SERVICE BULLETIN No.1180

COACH MODEL	: 2100 and C2000 Series
BULLETIN TYPE	: Service Information
SECTION	: Section 4 – Axles, wheels and tires
DATE	: October 12, 2006
SUBJECT	: Dana 11.36 drive axle w/ unitized wheel bearings - hub nut change
TERMS & CONDITIONS	: No claims will be accepted with reference to this Bulletin.

Figure 1: Previous and new fastener comparison

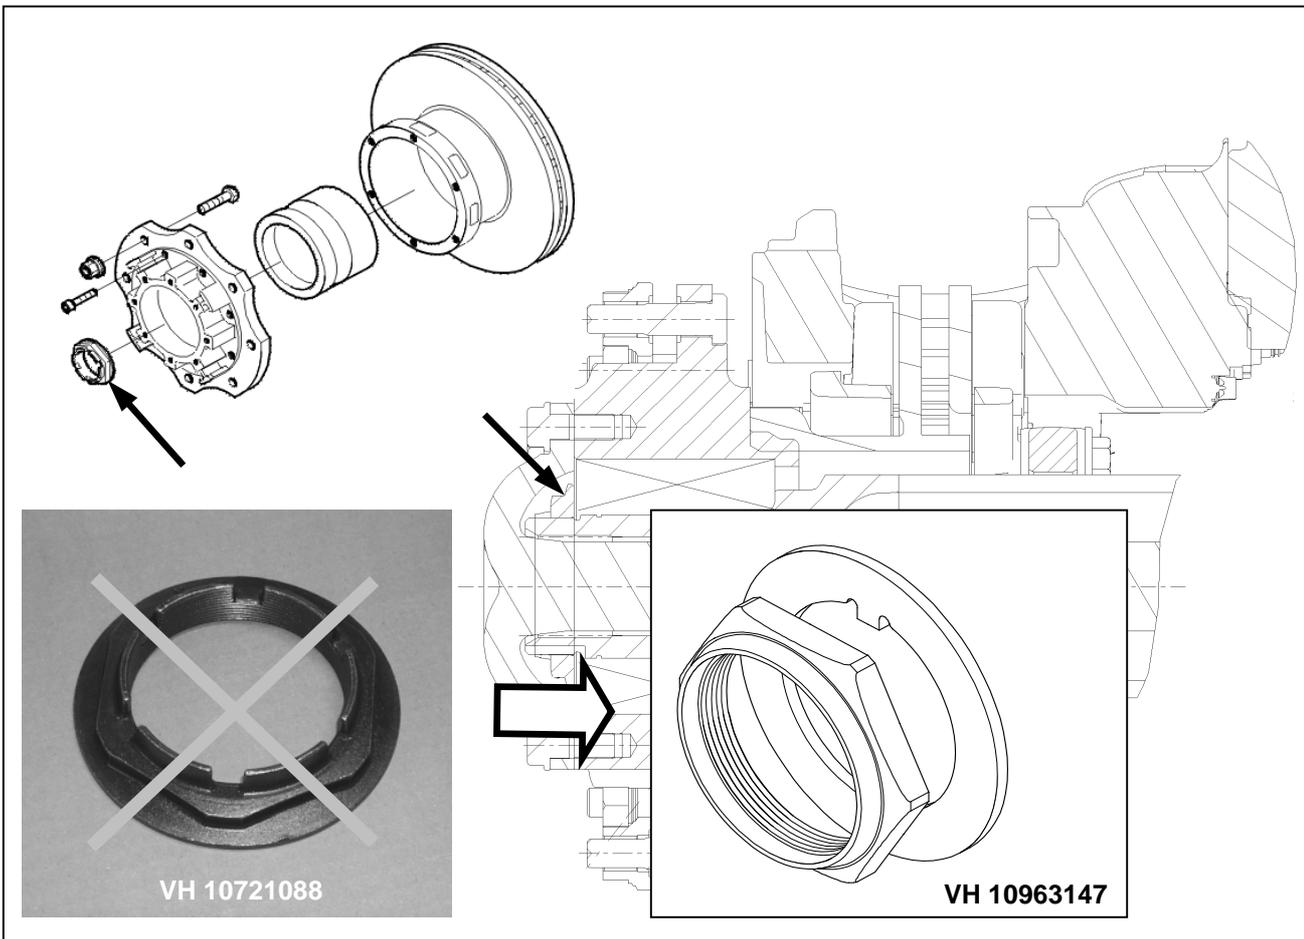
1. Dana Corporation have introduced new fasteners (kit # VH 10963147) to secure hubs with unitized bearings to the drive axle spindle.
2. All 11.36 axles produced after serial # P5628-04 incorporate the new fixation kit.

4. Dana recommend that all axles fitted with hub nut VH 10721088 (see Figure 1) are upgraded as described in this Bulletin whenever the hub installation is disturbed for any reason.

- Old and new parts are interchangeable, but only the new will be offered for service replacement.
- Parts may be purchased from your nearest ABC Customer Care & Parts Source service center.
- Parts and products disposition: discard according to applicable environmental regulations.
